November 29, 2016

Re: Comments on Draft Programmatic Environmental Impact Statement for Geological & Geophysical Activities on Gulf of Mexico Outer Continental Shelf

ATTACHMENT A

BOEM'S PRECAUTIONARY MODEL

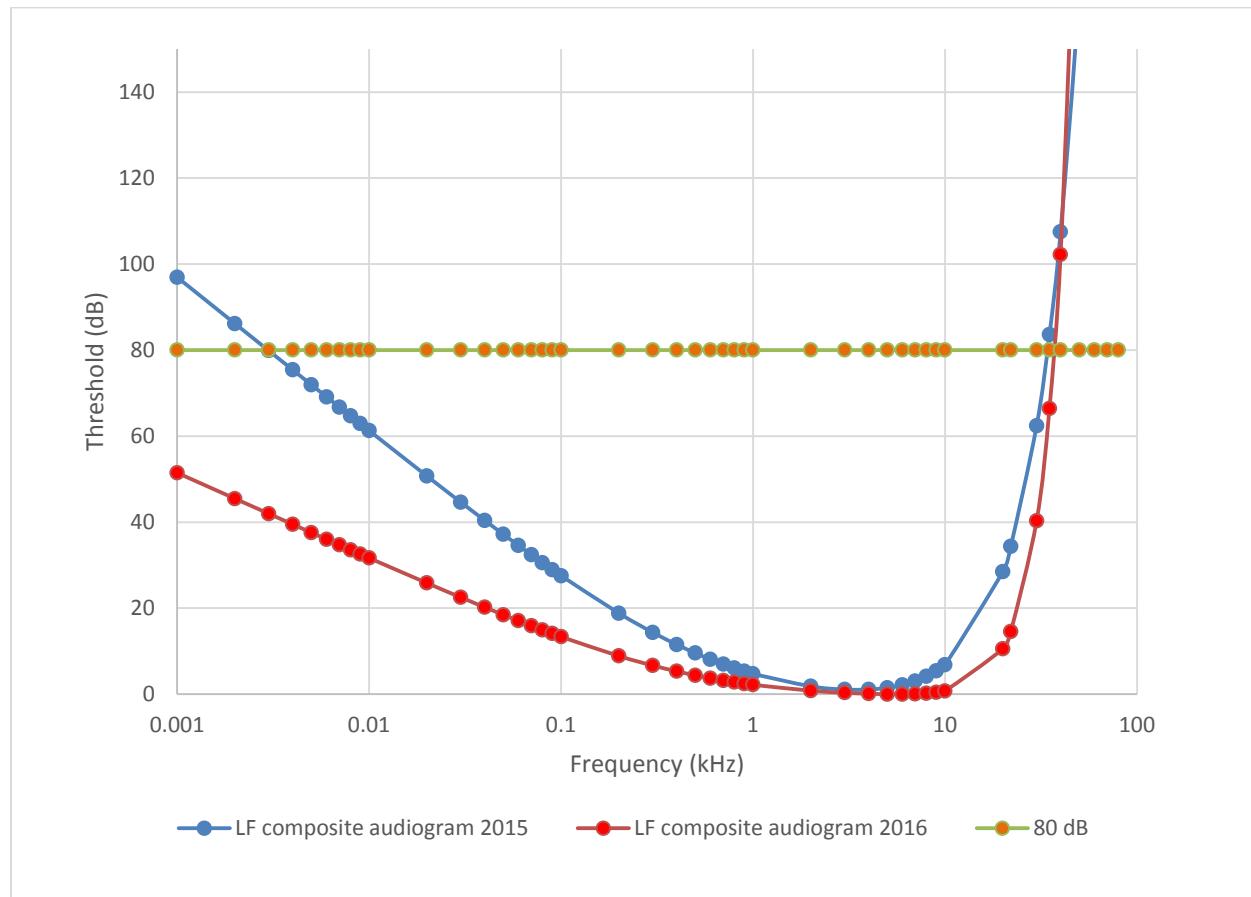
Figure 1. The consequence of the proposed changes to the LF cetacean modeled audiogram (in red) produce a hearing curve at the lowest frequencies that never approaches the 80 dB decrement from best hearing (in green) that NOAA had set as the upper and lower limiting frequencies of hearing (also a general mammalian metric of upper and lower hearing limits). The July 2015 modeled hearing curve (in blue), on the other hand, produces a crossing point with the 80 dB threshold at 3 Hz that provides a reasonable if generous lower limit of hearing.

In addition, on page 7 of the 2016 proposed changes, NOAA reviews four models for frequencies of best hearing and states that these models predict “thresholds within ~40 dB of best sensitivity as low as ~30 Hz and up to 25 kHz.” However, rather than use the predictions of these models, NOAA proposes a curve that predicts LF cetaceans can hear 30 Hz at 10 dB above best hearing, not 40 dB. Under NOAA’s model, whales could even hear sound at 10 Hz with only a 25 dB decrement from best hearing—which the best available science for baleen whale hearing modeling (*e.g.*, Houser et al. 2001; Cranford and Krysl 2015) and general mammalian hearing data strongly suggests is impossible. See *infra* footnote 8.

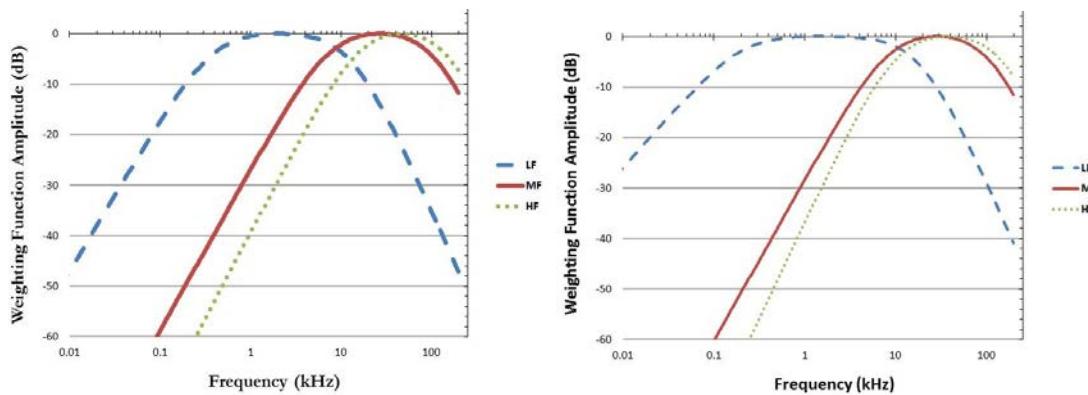
The impact of the new LF cetacean parameters is immediately obvious in our Figure 2 below, which compares Figure PC3⁷ of the new 2016 criteria (*see right plot below*) with the curve depicted in NOAA 2015 Draft Guidance (page 12) (*see left plot below*). In contrast to the similar shapes of all the 2015 weighting functions, the new LF cetacean curve produces a biologically unrealistic, extended, and flattened curve.

Figure 2. The left plot shows initial July 2015 cetacean weighting functions: LF in dashed blue, MF cetacean in red and HF cetacean in dotted black. While the frequency range of best hearing for LF cetaceans is conservatively generous given uncertainties in the models, the slope of the weighting functions are all parallel, consistent with what is generally observed across mammalian hearing and weighting functions. The right plot shows that the modified March 2016 weighting functions not only create a much broader and obviously unrealistic span of best hearing (the flat upper part of the curve normalized to zero), but also provide a slope of increased weighting (decreased hearing ability) at the lower frequencies that is clearly out of alignment with the measured decrement of hearing acuity in all other marine mammals, as well as for mammals in general, including other LF specialist species.

NOAA's proposed LF cetacean model also sharply deviates from data pertinent to other LF specialist mammals. For example, humans are LF hearing specialists that have a best hearing range of approximately 400 Hz to 16 kHz.⁸ But, unlike the LF cetacean model proposed by NOAA, human hearing ability is 25 dB below best hearing at 200 Hz—not the 10 Hz value generated by NOAA's proposed hearing curve. As another example, the kangaroo rat (another LF hearing specialist) has best hearing that starts to diminish at approximately 500 Hz. By 100 Hz, the kangaroo rat's hearing threshold is at least 10 dB above best hearing, and at 20-30 Hz is
